Your Ref: Torquay Amendment Order No2 2024

Proposed Traffic Regulation Orders (TROs): Torquay Amendment Order No2 2024

This Consultee Response has been reviewed and agreed by the Steering Group of the Torquay Neighbourhood Plan Forum.

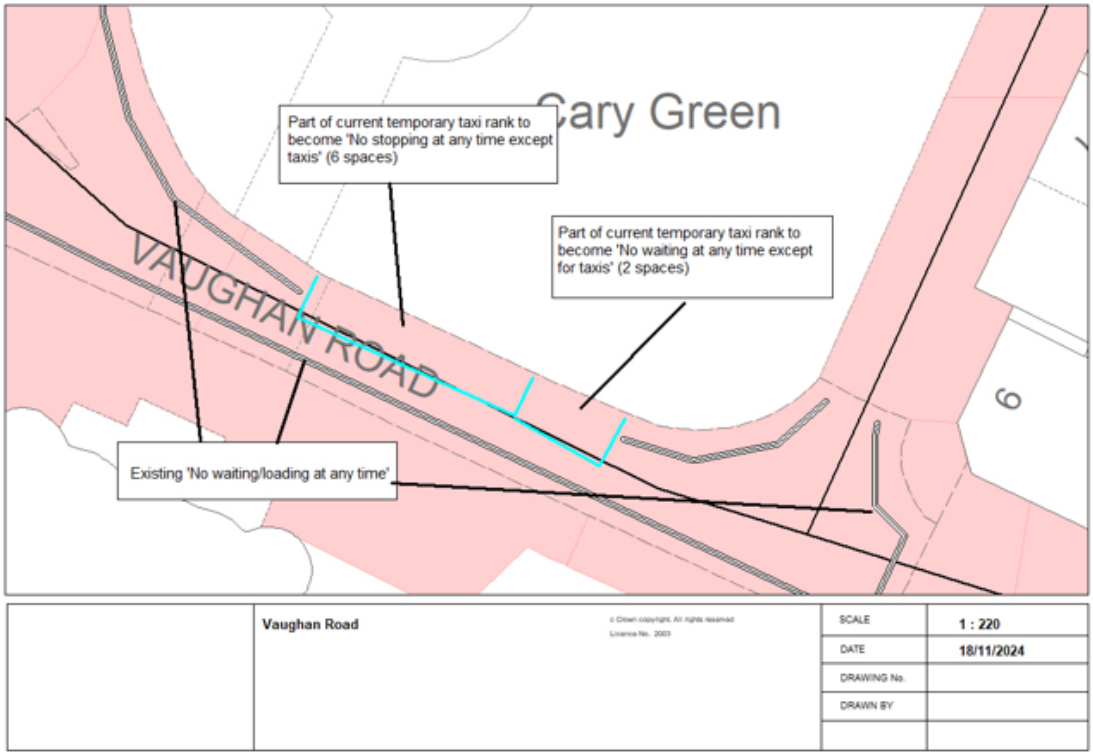
The Torbay Council website provides a link to the "Notice of Proposals" and the accompanying Schedules. The map showing the location of the permanent taxi rank is reproduced below:

The pink coloured areas are the highway. The existing "No waiting/loading" lines on the road are shown on the map. The drawing implies that the taxi bays (outlined in blue) are **all to be on the existing highway and will not encroach onto the Green**.

The dotted lines in the photo are what is outlined in blue on the map. But as can be seen, the taxi bays are not on actually on the existing roadway at all, but entirely on the Green.

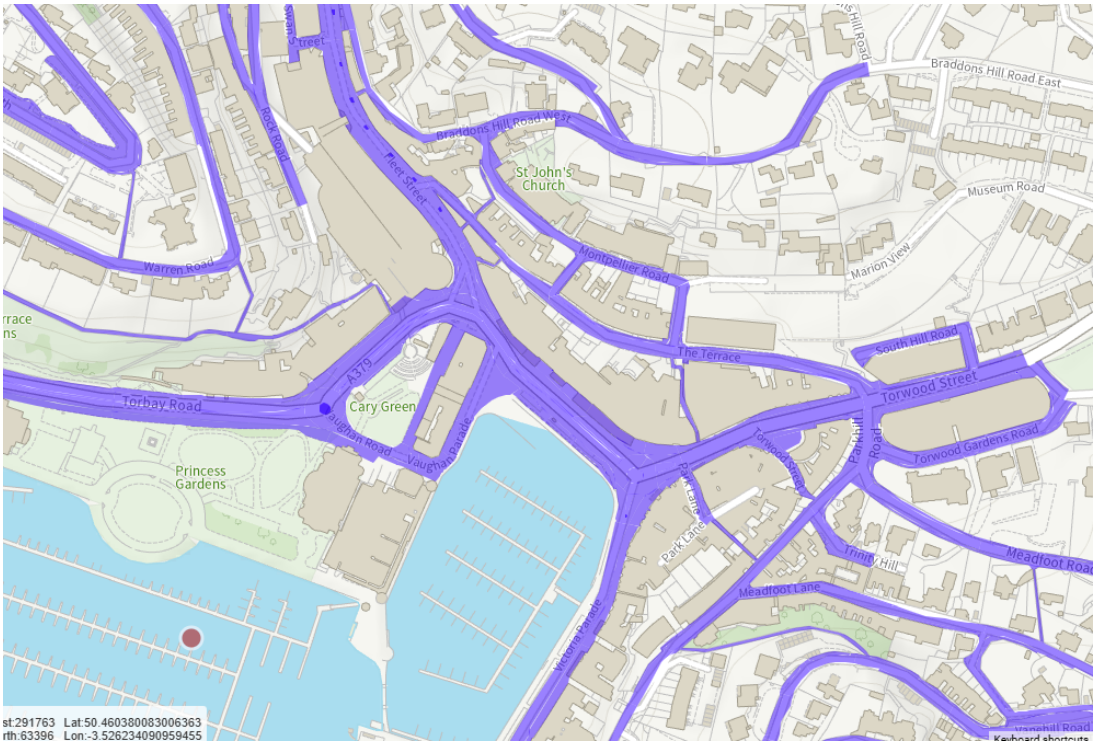
The diagram below (taken from Torbay Council's website) shows the adopted highway network in Vaughan Road and Palk Street.

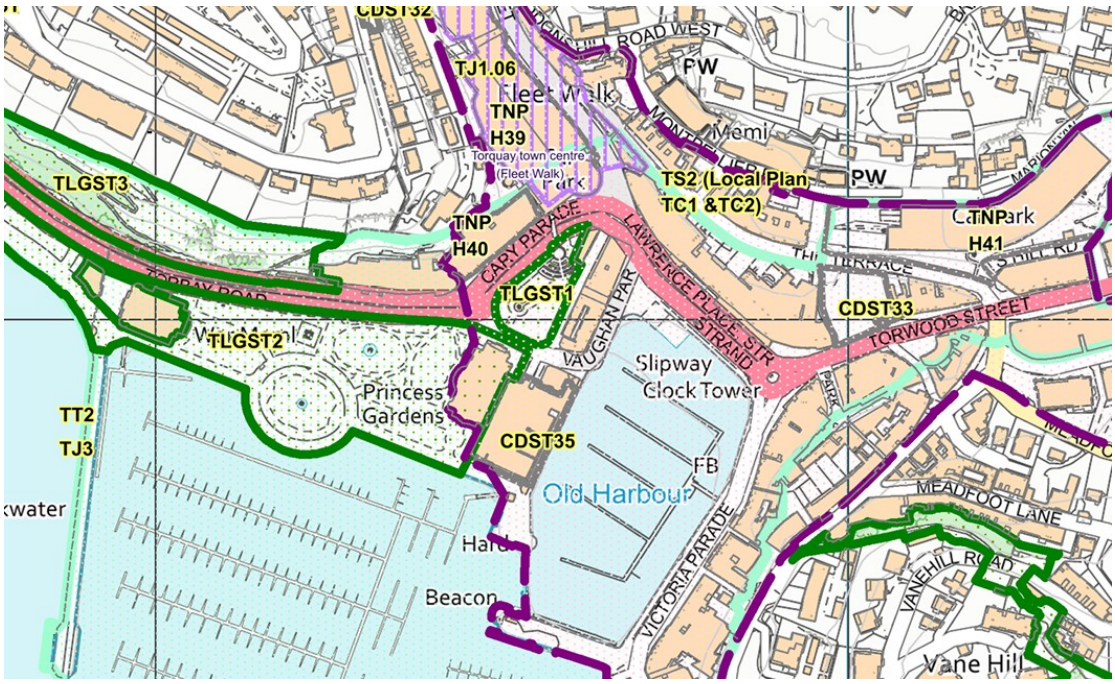
A map showing that Cary Green is designated a Green Space may be found on here: https://www.torbay.gov.uk/media/13831/torquay-neighbourhood-plan-policy-map-sheets-11-19.pdf. The relevant part of the map is reproduced below:

It is our submission that the taxi parking that will occupy some of this local Green Space permanently does not meet the criteria of Policy TE2 in that there are no "**very special circumstances**" to justify this loss of Green Space.

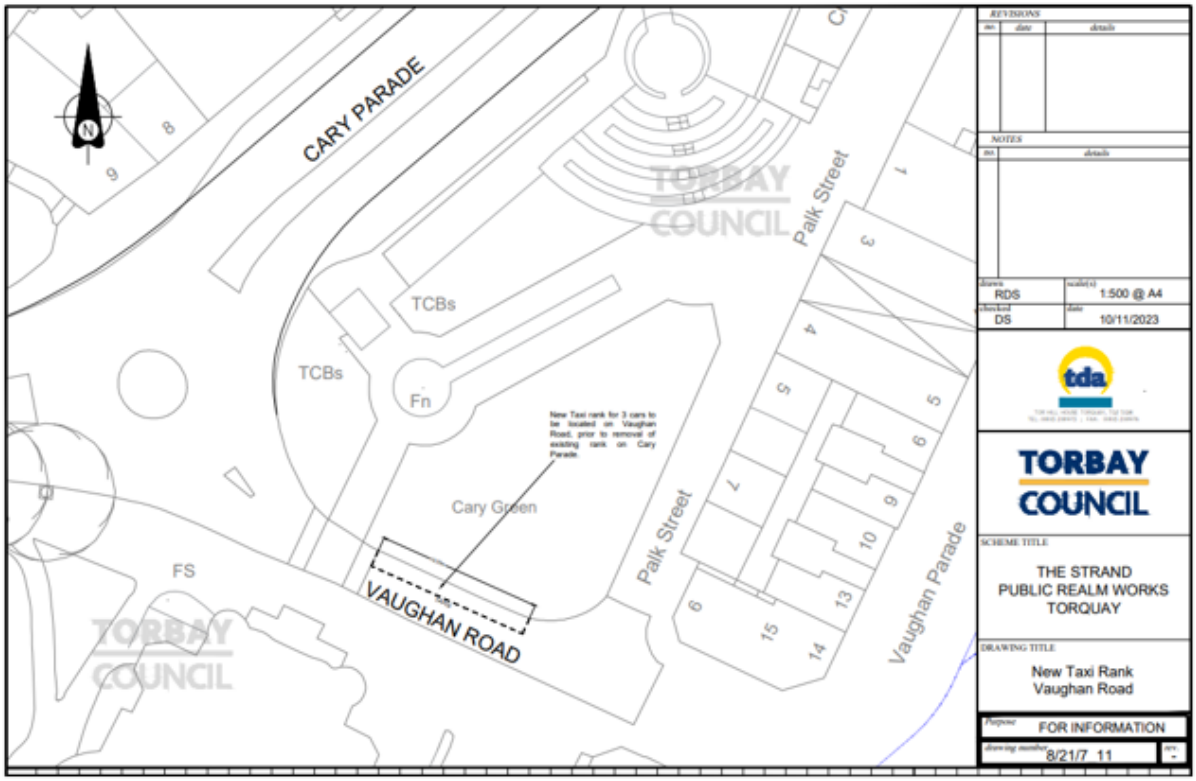
Furthermore, the diagram in the TRO for the temporary taxi rank shows that this was for three vehicles only, parallel-parked to the curb and entirely on Vaughan Road. See diagram below:

HOWEVER, what has actually been created as a temporary rank is different from this as the vehicles are parked perpendicular to Vaughan Road and entirely on Cary Green.
